Prepared for:
Art Gallery of New South Wales Trust
Date:
21 February 2022
Image:
Aerial photo of the Sydney Modern
Project © Craig Willoughby
November 2021

Section 4.55(1A) Modification – Minor Design Changes

Art Gallery of NSW Expansion Project – Sydney Modern

Figure 3 Proposed Site Plan
Source: SANAA and Architectus (2022)

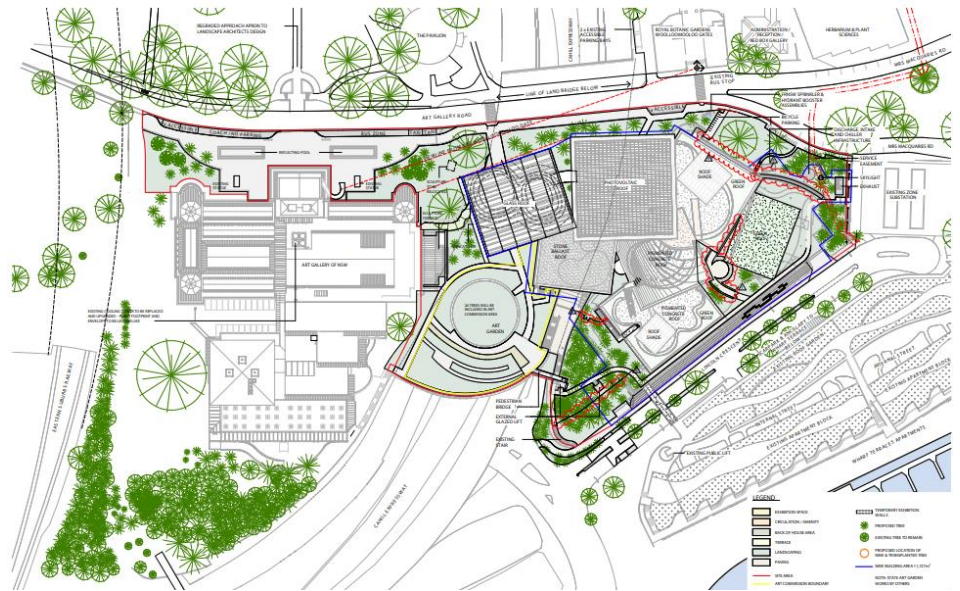
Medich Garden (*numbered 1 on the Amended Architectural Plans and 3 on the Amended Landscape plans*)

The Medich Garden is a proposed and approved courtyard. Its layout has been modified to accommodate an increased pavement area. This change results in reductions to and relocation of understorey planting as well as materials.

Relocation of Planters and Furniture at the Entry Plaza (*numbered 2 on the Amended Architectural Plans and 1 on Amended Landscape plans*)

As a result of continuing design development, and as a result of the placement of sculptures, there has been a minor rearrangement in the location of furniture and planter boxes within the Entry Plaza. The pot sizes of potted trees have been updated to accommodate these changes and also the latest procurement availability of the tree species. The potted trees are now more in scale and sited appropriately relative to sculptures, furniture, grades and functionality of spaces in the Entry Plaza.

Safety Barrier to landscaped area over the Lincoln Lobby (*numbered 3 on the Amended Architectural Plans and 5 on Amended Landscape Plan*)

For safety reasons, an additional pipe handrail has been introduced between the end of a previously proposed balustrade and existing stairway on the southern boundary of the site above the Lincoln Crescent escarpment.

Swale and Safety Fence (*numbered 4 on the Amended Architectural Plans and 6 on Amended Landscape Plans*)

A swale which captured overland flow into a channel was previously approved adjacent to Gallery 2 and along the Rammed Earth Wall (REW) to the north of the Multipurpose space. This stone lined swale was captured on Landscape sections LD-DA-50-01.

The Architectural and Landscape drawings have been updated to capture this drainage requirement on all relevant plans. Furthermore, a safety fence is proposed on the western edge of the swale to limit access.

Service Enclosure at Ming Wei Entry Door (*numbered 5 on the Amended Architectural Plans*)

A service enclosure has been introduced to provide for an airtight enclosure to the Ming Wei sliding door. The enclosure is not visible to the public.

Relocation of security fence adjacent to Gallery 3 (*numbered 6 on the Amended Architectural Plans and 4 on Amended Landscape plans*)

The security fence near the southern façade of Gallery 3 and the rammed earth wall have been shortened, to be less intrusive and allow a better view of the stone-faced façade.

Relocation of security fence adjacent to Multipurpose Space (numbered 7 on the Amended Architectural Plans and 4 on Amended Landscape plans)

The security fence near the eastern façade of Gallery 3 and multipurpose space has been redesigned to a different alignment. The north end termination at the rammed earth wall has been adjusted to better integrate with the safety fence along that wall.

Figure 4 Proposed Landscape Masterplan – Drawing no. LD_DA_00-01 – Modification 8
Source: McGregor Coxall (2022)

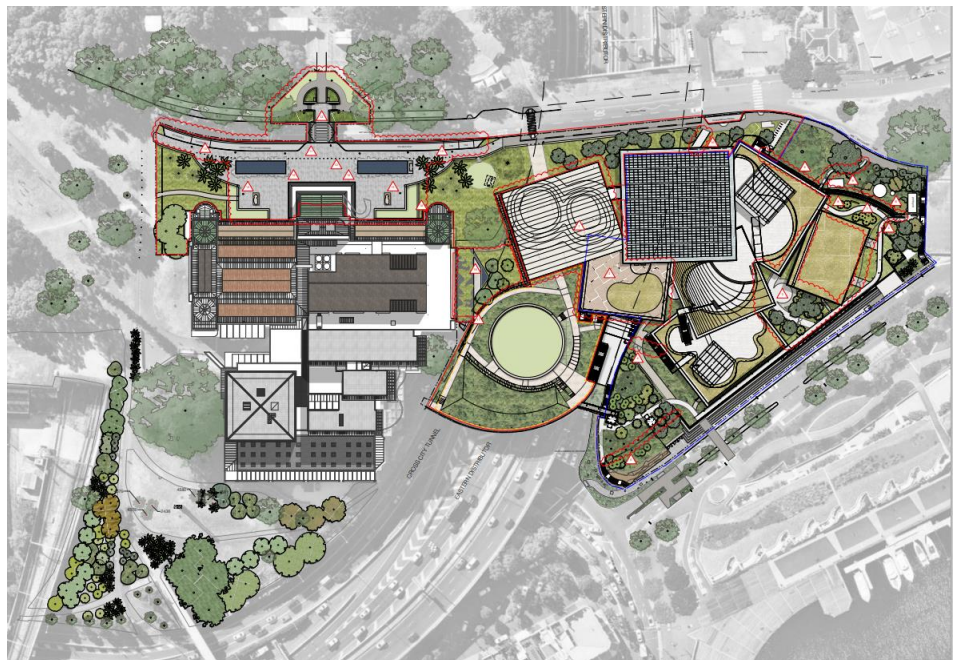
LL2 Tree Relocation (numbered 8 on the Amended Landscape Plans)

A previously approved proposed tree adjacent to Gallery 7 has been relocated to the adjacent tree cluster to reduce the extent of deep soil build-up at the location where the slab span would be at its longest.

Gallery 2 egress handrail (numbered 9 on the Amended Landscape Plans)

A physical barrier is to be installed as a risk mitigation measure north of the Egress Path from Gallery 2.

Entry Pavilion Access Handrail (numbered 10 on Amended Landscape Plans)

Addition of two removable handrails as a safety requirement for access to and from the Entry Pavilion.

Forecourt Walls at Wombat Crossing Removed (numbered 11 on Amended Landscape Plan)

The forecourt walls at Wombat Crossing have been removed and replaced with bollards 3m away from kerb. These changes have been made as a design response to City of Sydney requirements regarding safety performance.

Forecourt and Domain Bollard Adjustments (numbered 12 on Amended Landscape Plan)

The bollards that have been approved at the Domain have now been removed. The bollards approved along Art Gallery Road have been relocated away from Art Gallery Road kerb to be in-line and set back 3m away from the kerb.

External Lighting (numbered 13 on Amended Landscape Plan)

The location of external lighting has been updated to reflect the revised lighting and services design.

Existing AGNSW Building North Retaining Wall Extension (numbered 14 on Amended Landscape Plan)

The retaining wall adjacent to the existing dish gutter of the existing AGNSW building will be extended to improve surface drainage away from the building.

Water Feature Skate Deterrent Paving (numbered 15 on Amended Landscape Plan)

The paving layout within the forecourt to the existing AGNSW has been amended in response to skate deterrent strategy.

Terrace Water Feature and Garden Alignment (numbered 16 on Amended Landscape Plan)

The water feature has been updated during design development. The garden bed between the terrace water feature and rain catcher has been redesigned to accommodate a higher capacity passive drainage strategy.

Sculpture Garden Trellis (numbered 17 on Amended Landscape Plan)

The Trellis post locations have changed location due to constraints of existing conditions of the existing concrete slab and land bridge foundations.

Lincoln Crescent LL2 Treatment (numbered 18 on Amended Landscape Plan)

Planting at the second tier above the Fuel Bunker Wall has been removed to deal with the capacity of stormwater overland flow along the LL2 footpath.

Figure 6 Proposed layout of trees – Modification 8
Source: McGregor Coxall (2022)

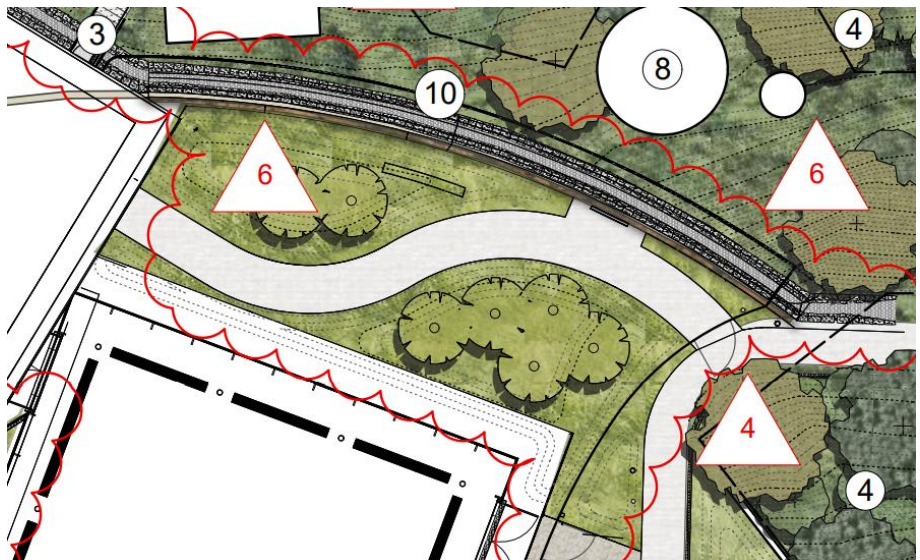
The Proposed Modification will relocate one (1) previously approved tree closest to Gallery 7 to the adjacent tree cluster. The relocation of this tree will aim to reduce the extent of deep soil build-up at the location where the slab span would be at its longest. This relocation is illustrated in **Figure 5** and **Figure 6** below.
